Tender Clarification Notes - Technical

Please note the following technical clarification points relevant to the enquiry:

Image 1. Lethabo Solar PV site locates services

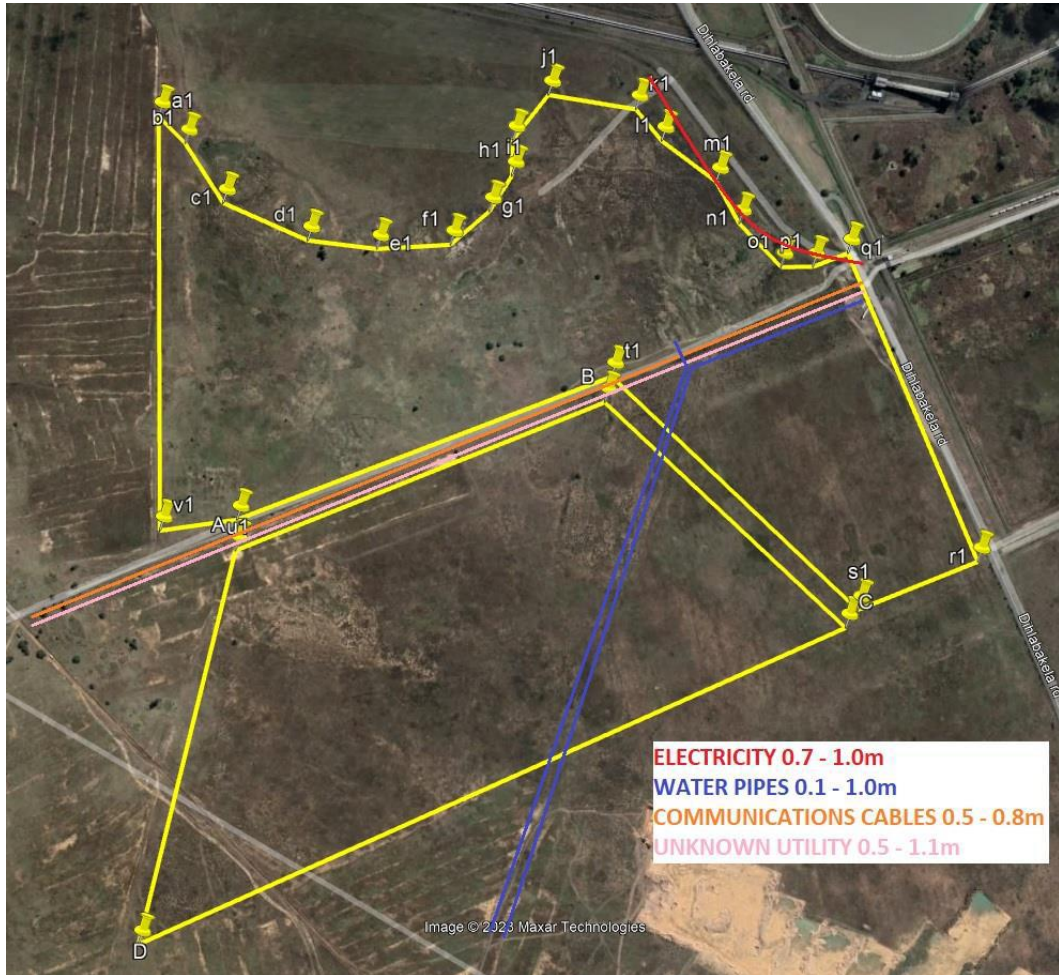
- The PV facility design needs to take into consideration the existing utilities as indicated in the Geotechnical Investigation Factual Report for the Proposed Lethabo Solar PV, Appendix N: Service Detection Report and Layout. Special attention needs to be given to the existing water pipeline (indicated in blue), which could be prone to leaks and would require repairs from a 3rd party.
